**From:** Stacie Greer <sgreer@maletis.com>  
**Sent:** Thursday, March 01, 2018 9:34 AM  
**To:** Ballew, Cassie  
**Cc:** Heron, Tim; greg@virtualvenues.com; jcarrpdx@gmail.com; staciegreer@gmail.com  
**Subject:** Design Commission Review proposed Powell Storage Development (Case Number: LU 17-144195 DZ)  
**Attachments:** Stacie and Greg Greer in Support of Appeal.pdf  
**Importance:** High

We are writing in support of the South Tabor Neighborhood Association appeal of the proposed storage facility at SE 62<sup>nd</sup> Ave and Powell. Case Number: LU 17-144195 DZ.

**Exhibit 4:** Please note that the truck using the turnaround space is hitting the fence. The truck in the diagram is only 30 feet long, not the largest trunk rental available.

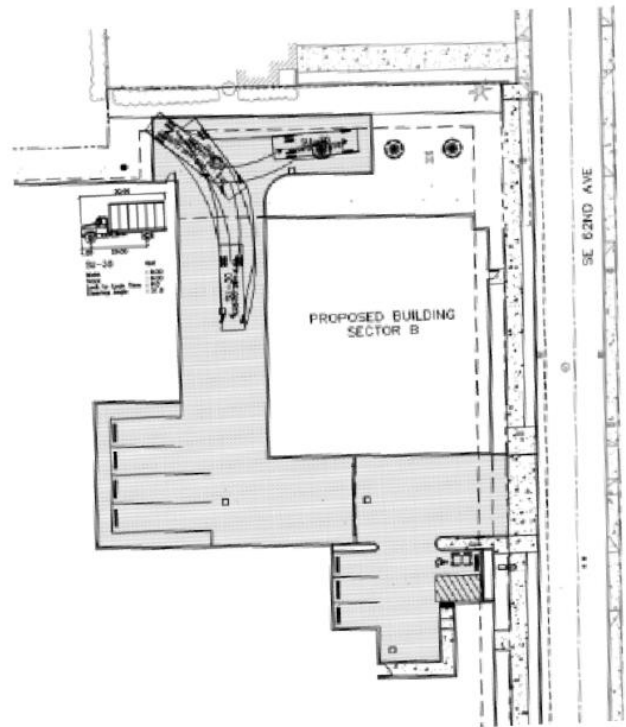
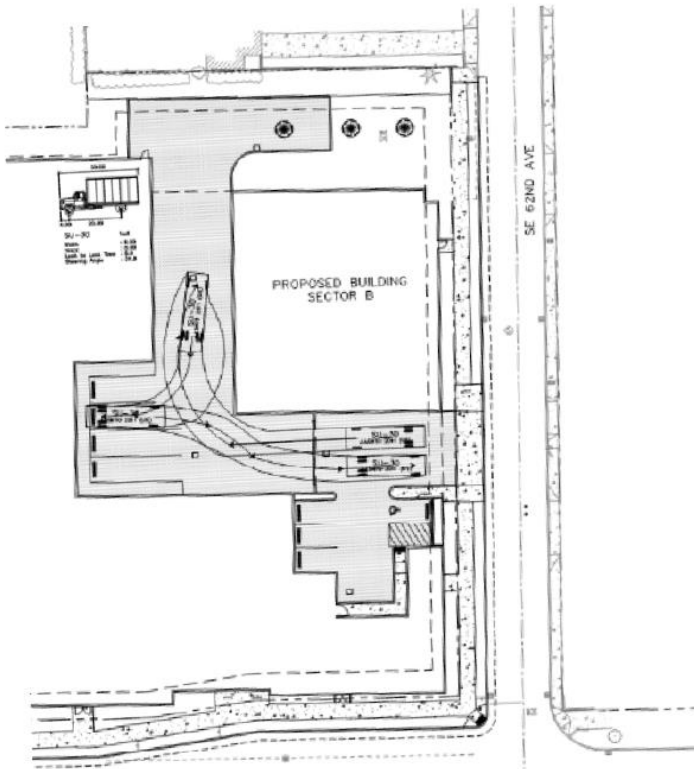
- Please see attached image Exhibit 4 (provided by the applicant) from Exhibit H 31 John Carr. The truck accessing the turnaround space is hitting the fence. The truck is only 30 feet in length. Not the largest rental available.

Exhibit 6A: Wood fence on design, metal fence in rendering.

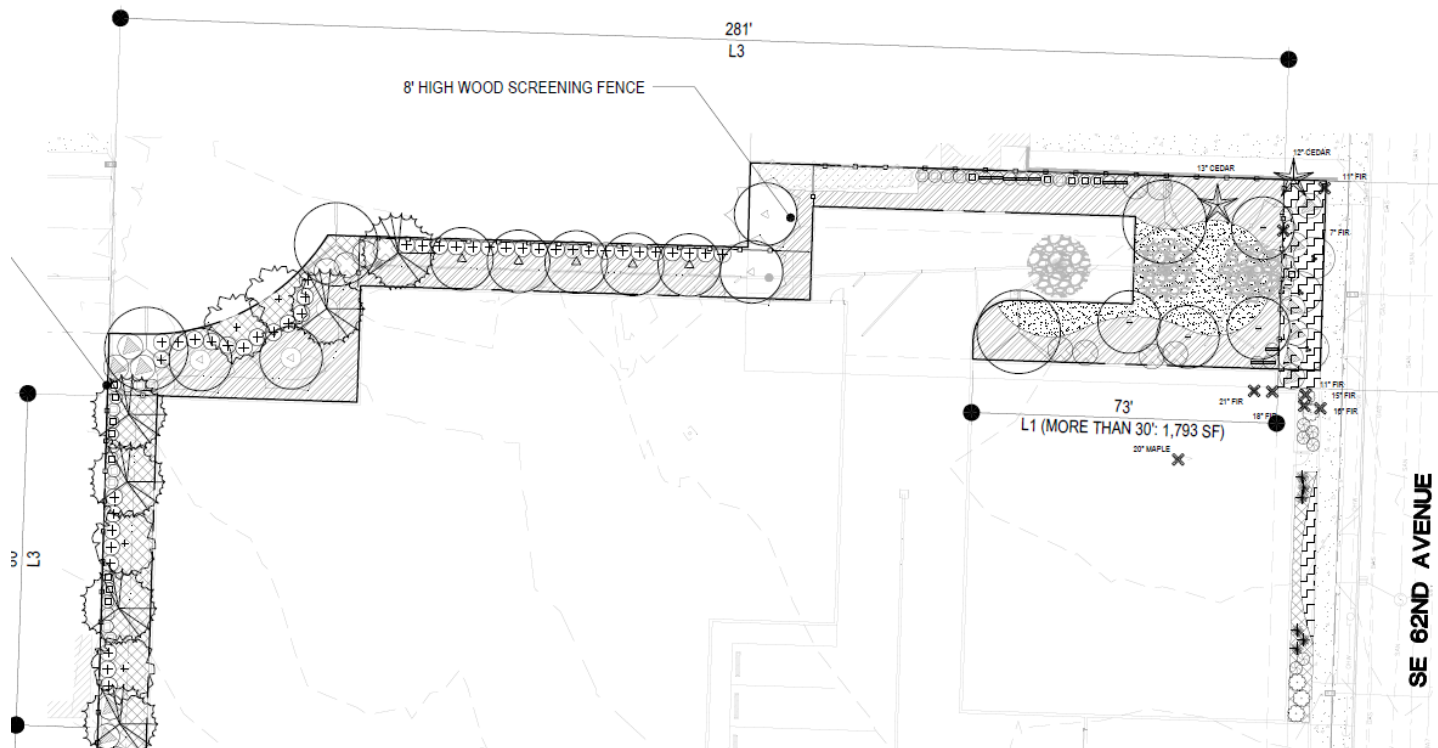
- The applicant states that they have secured the entire property with fencing in exhibit H 33 Applicant. The rendering shows a metal fencing around the property (except where there is an existing wood fence on the westside). The plans show an 8 ft. wood fence on the north/northeast portion of the property (different than the rendering and in the statement, they included, see attached Exhibit 6A & B). We ask for clarification of the type of fencing being used in these locations.

**Exhibit 6B:** Northeast property line fencing (our home/driveway, 3333 SE 62<sup>nd</sup> Ave is missing from picture)

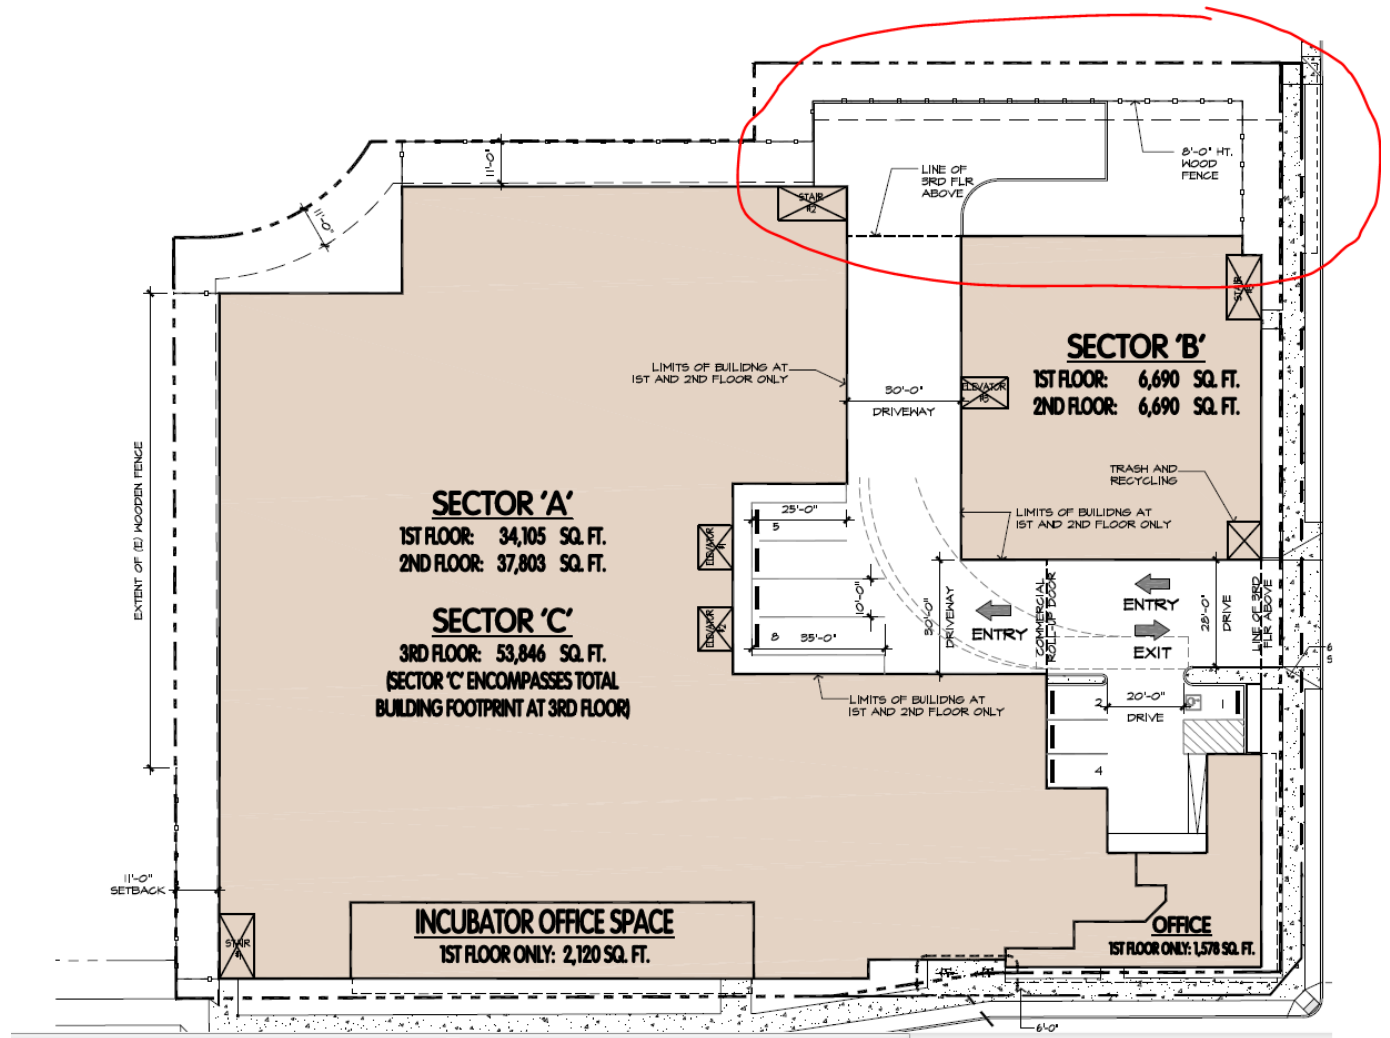
- Additionally, we ask for clarification as to when the fence is being placed on the north property line and where is it set back from the north property line. The objective being to not leave open channels for people to walk thru or to enter our property which creates a security risk.
